SUBJECT: Advises that Section 14.2.14.3.17 will be amended to remove any ref to containment hot pipe penetration testing, SER Outstanding Issue 21 (NUREG-0892) closed w/o need for acceptance criteria. Diagrams re penetration assembly encl.

October 4, 1982
G02-82-822

Subject: NUCLEAR PROJECT NO. 2
SAFETY EVALUATION REPORT, NUREG-0892,
OUTSTANDING ISSUE (21), CONTAINMENT
HOT PIPE PENETRATION TESTING; CLOSURE OF

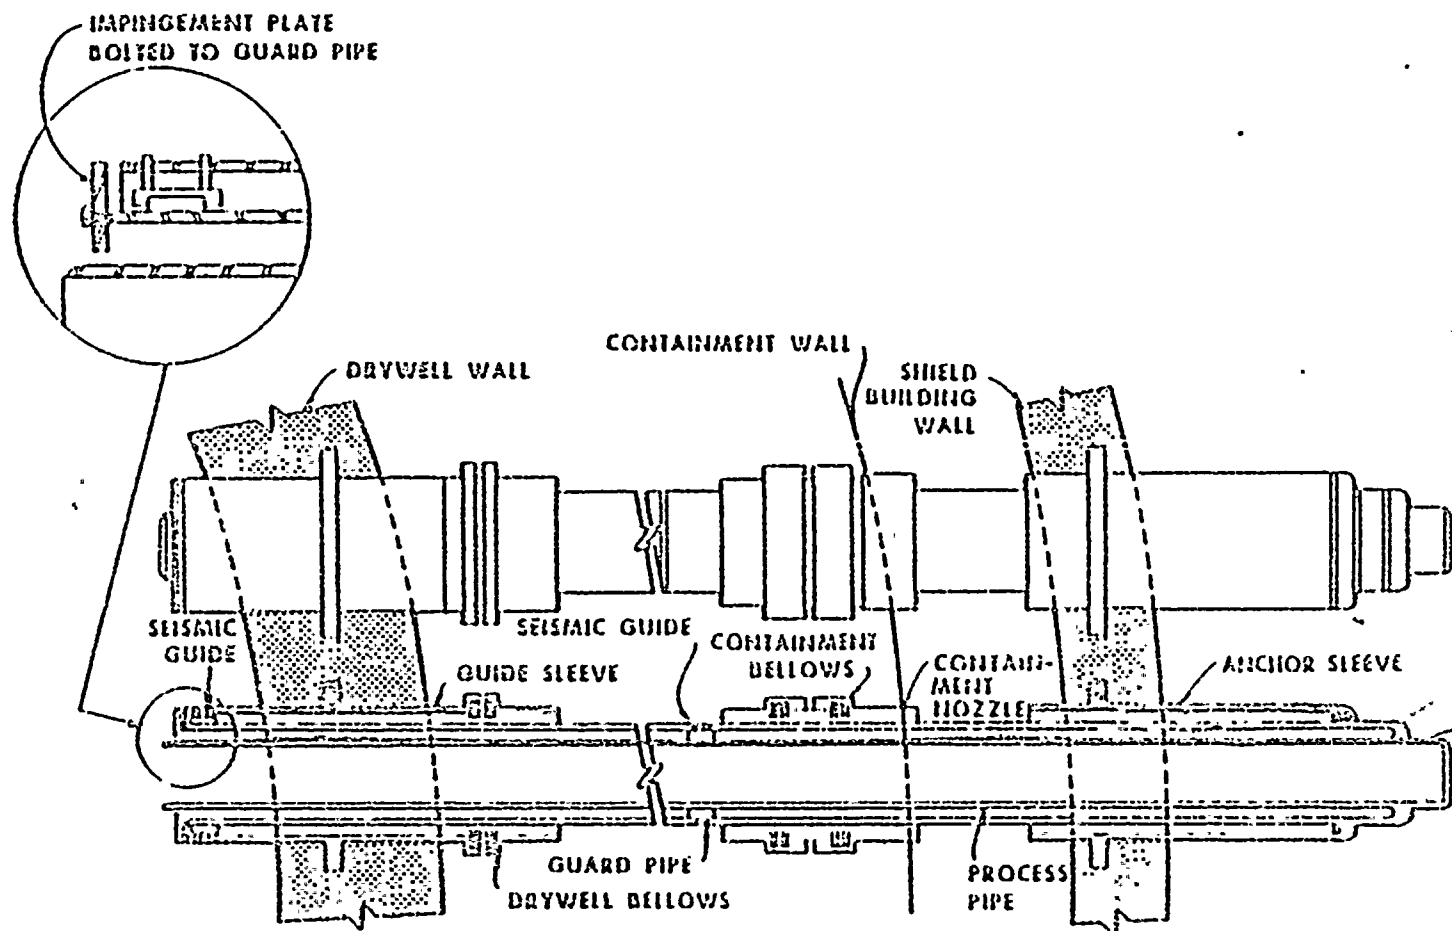
The GG containment is a Mark III design in which process piping penetrates the concrete drywell wall (see Attachment #1). The drywell wall provides the boundary that forces steam, in the event of a loss of reactor coolant system integrity, into the suppression pool for primary containment pressure control. The concern at GG is concrete degradation of the drywell wall due to inadequate hot pipe penetration cooling. In order to satisfy the ASME B&PV code limit of 200°F, GG analytically determined the need for cooling fins to be added to selected hot pipe penetrations design. The issue at GG is clearly a concrete degradation problem, as the "drywell wall" was the area of concern.

Guard Pipe Assembly

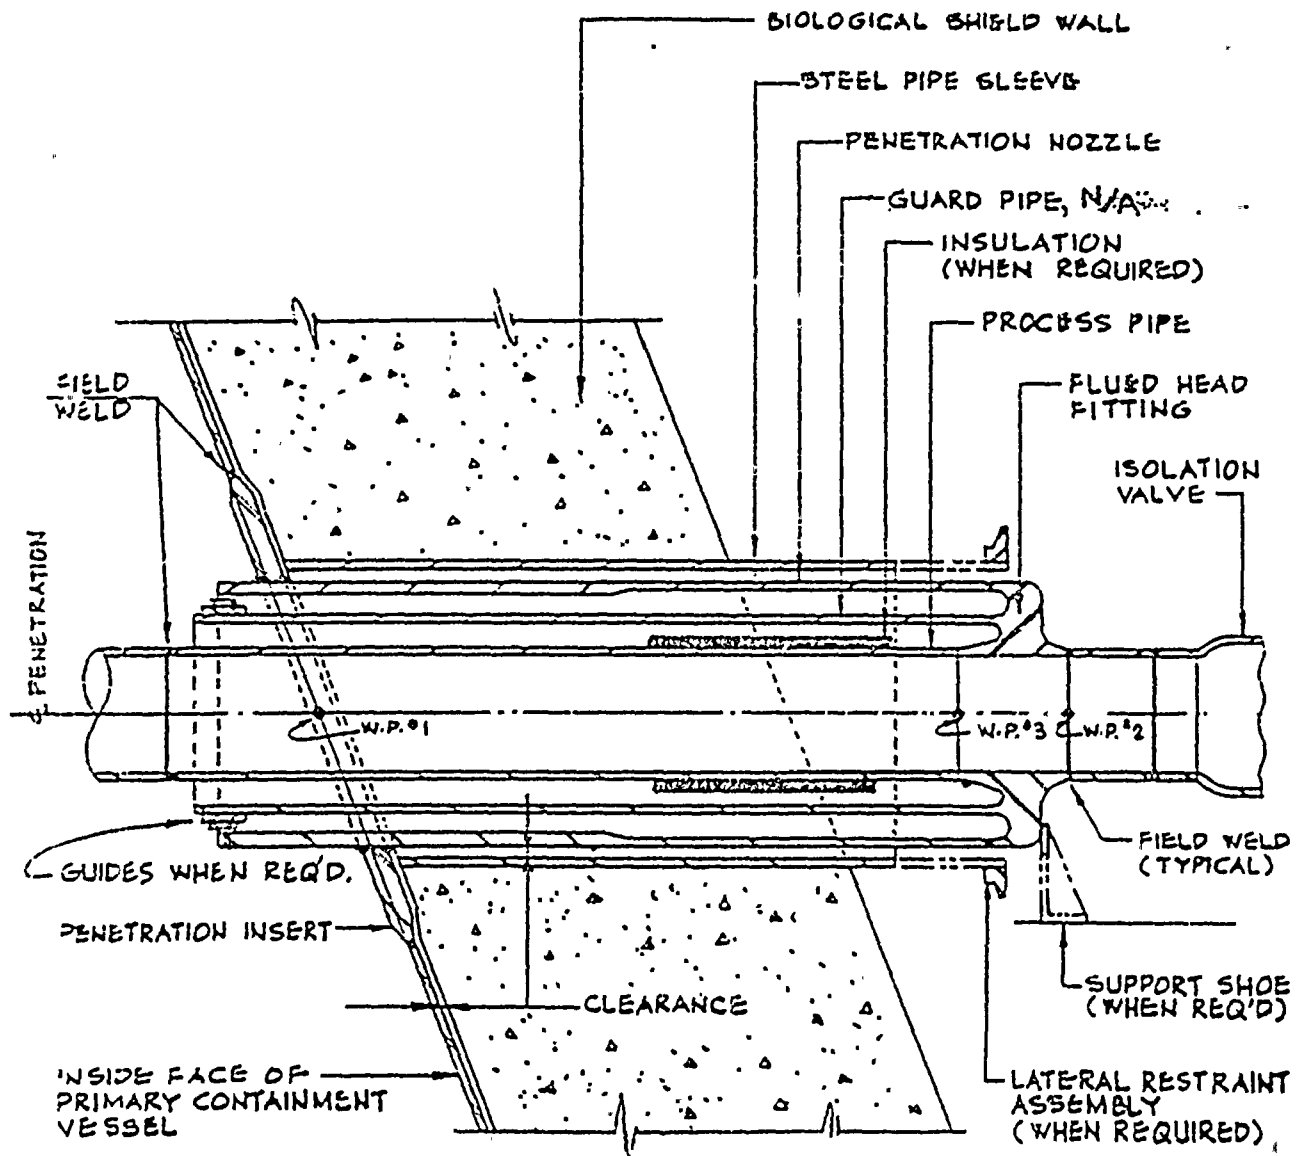
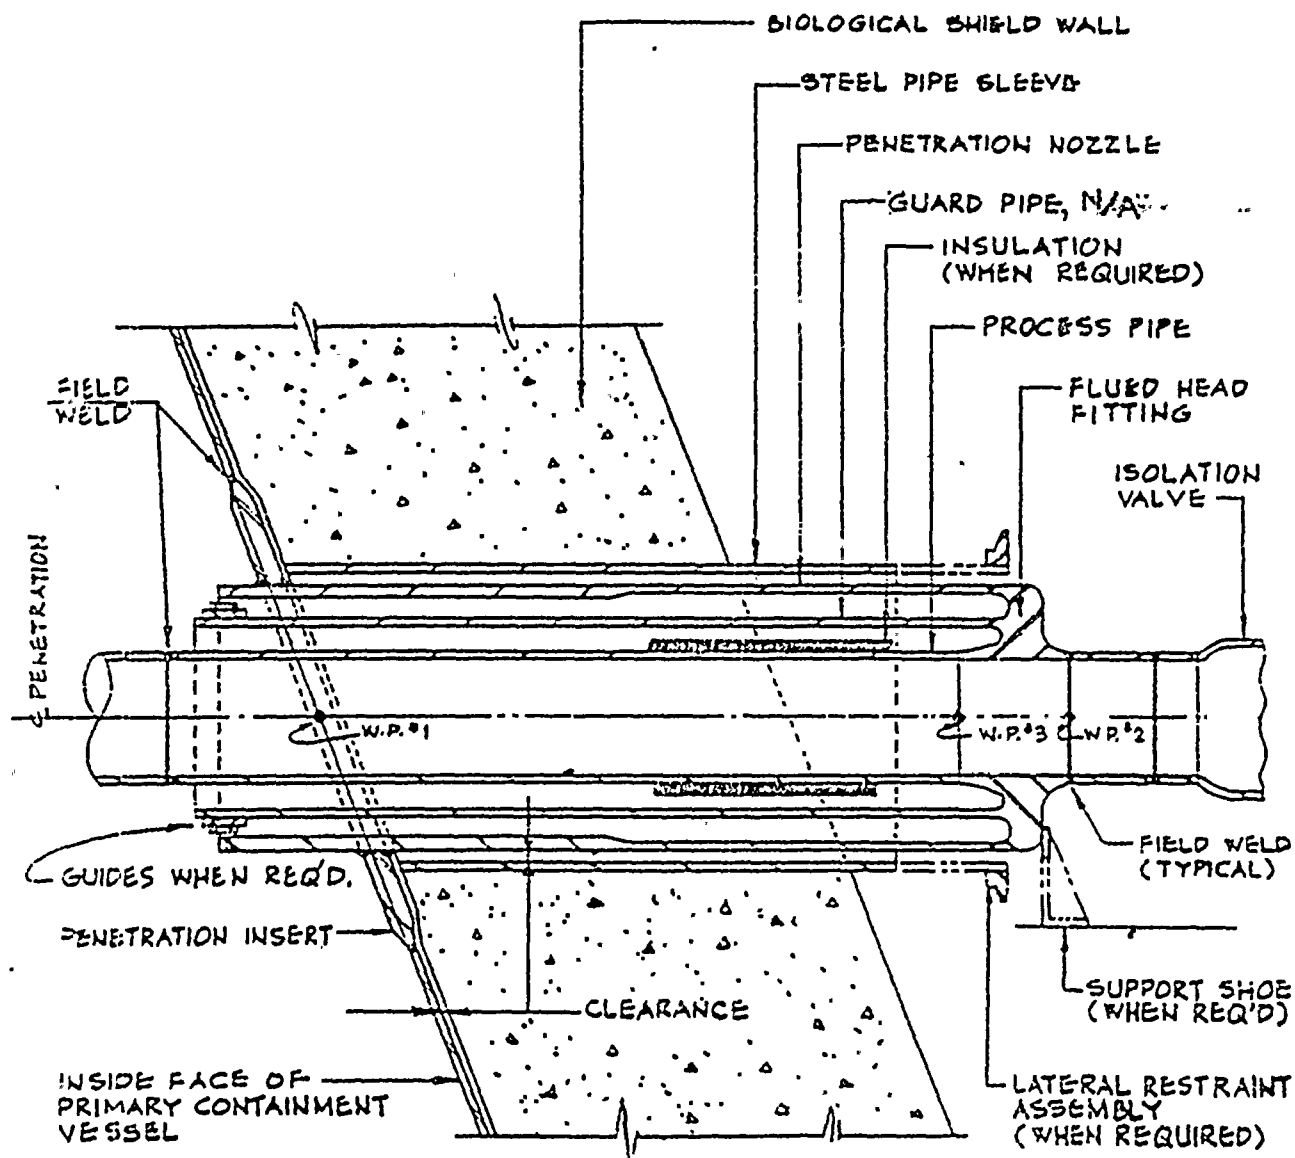
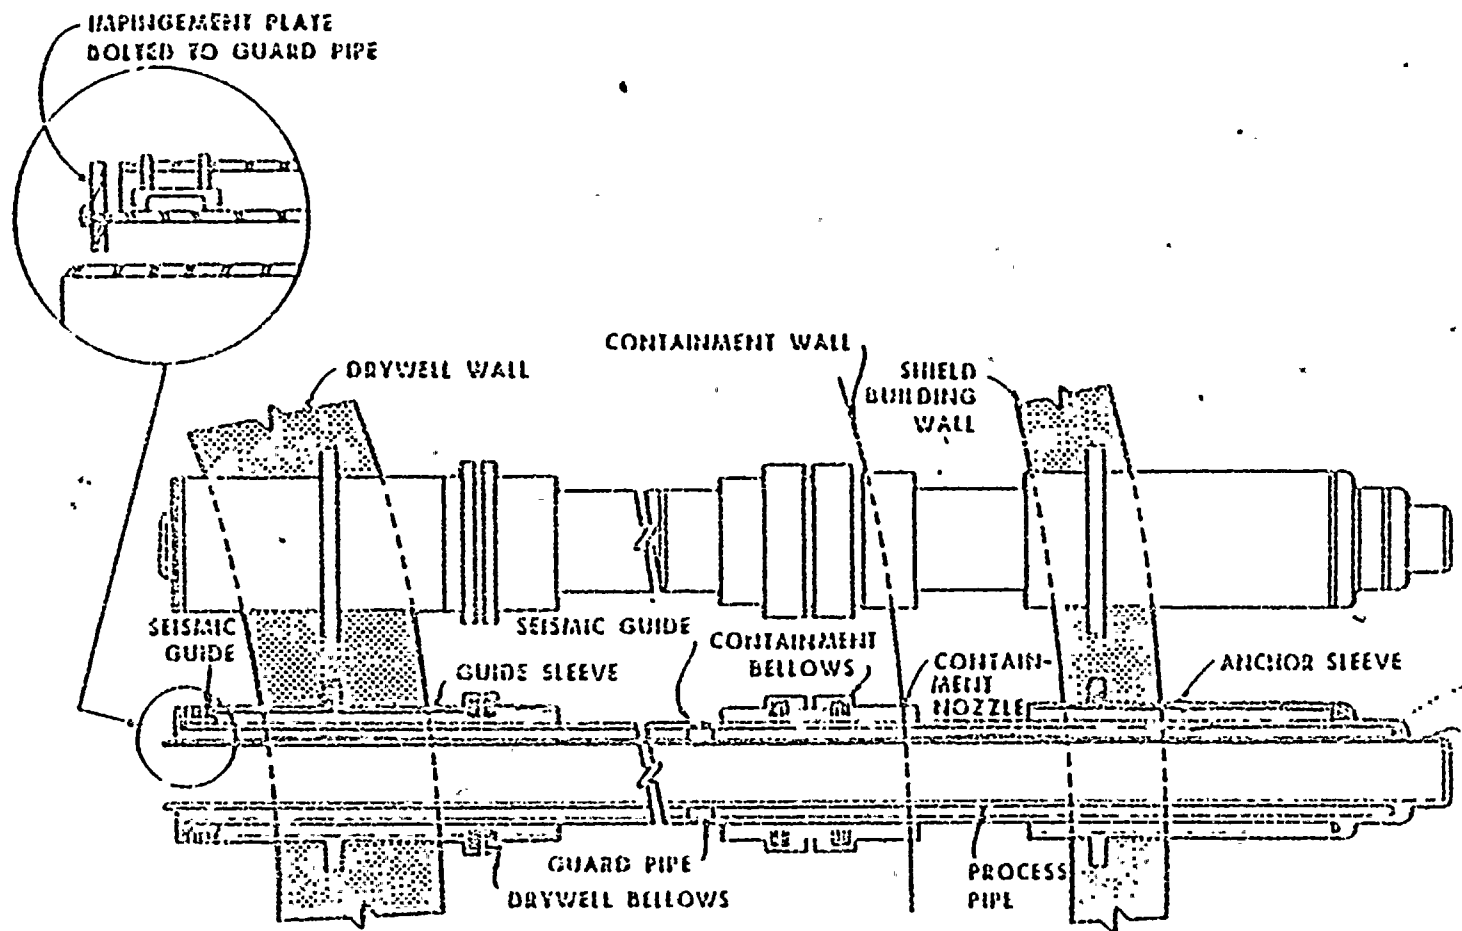
WNP-2 is a Mark II containment design, employing a free-standing steel pressure vessel. The penetrations are a composite design consisting of a penetration nozzle, insulation, flued head fitting and the process pipe (see Attachment #2). The biological shield wall is penetrated through a pipe sleeve which provides no direct penetration support. The bio-shield wall also provides no support for the primary containment vessel. The primary

containment penetrations at WNP-2 experience similar operating conditions as the containment and shield building wall at GG, and it is evident from the GG issue that the containment and shield building wall was of no concern. Therefore, the licensing concern at GG is not applicable to WNP-2. It is of significance to note that no other BWR has included this type of testing in the Power Ascension Testing Program and the issue at GG represents a plant specific issue.

In view of the above, WNP-2 Section 14.2.14.3.17 will be amended to remove any reference of hot pipe penetration testing. Additionally, the Supply System considers SER Outstanding Issue #21 closed without need for acceptance criteria.
